**SB-GA8-2023-216**

# Service Bulletin

Relay Box Bonding

**Figure 1: Wire PE5A18N Fabrication Details**

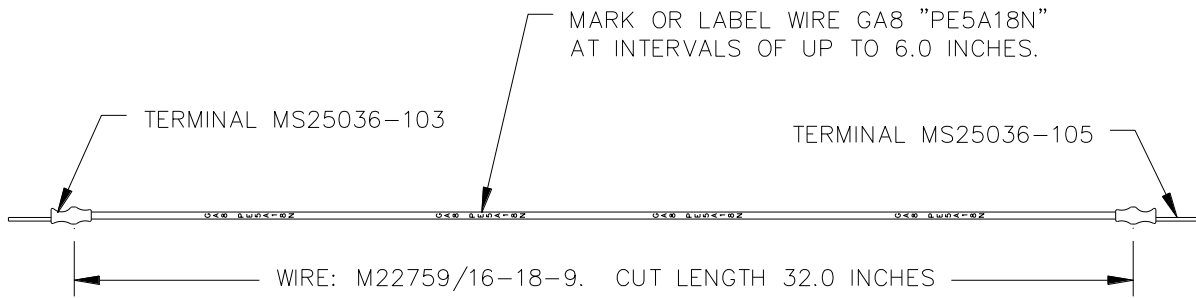
For aircraft requiring the installation of the connection, the parts required may be sourced locally in accordance with Figure 1. Alternately, P/No GA8-246015-053 may be purchased from GippsAero.

**Figure 2: Wiring Schematic**

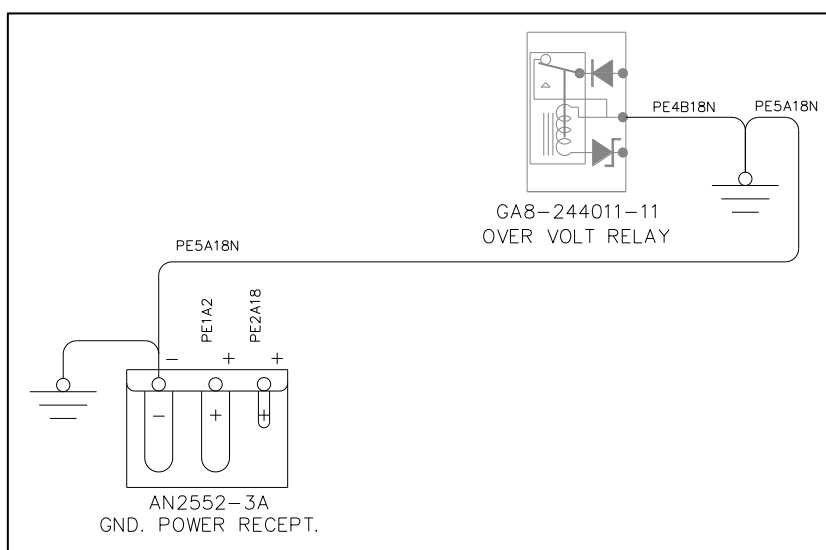
- Using P/No. GA8-246015-053 (or locally fabricated equivalent), connect the earth terminals of the over-volt relay and ground power socket.
  - Bundle the new wire with the existing ground power connections. Ensure that wire is appropriately restrained and protected.
  - Connect wire to ground power receptacle, earth terminal in accordance with Figure 2.
  - Connect wire to relay box ground point in accordance with Figure 2 and Figure 3.
- After the mechanical connection is completed, measure the resistance for the new connection. Place one probe on the relay box ground point and the other on the engine frame or other suitable airframe earthing point. The resistance is required to be 0.1 ohms or less.
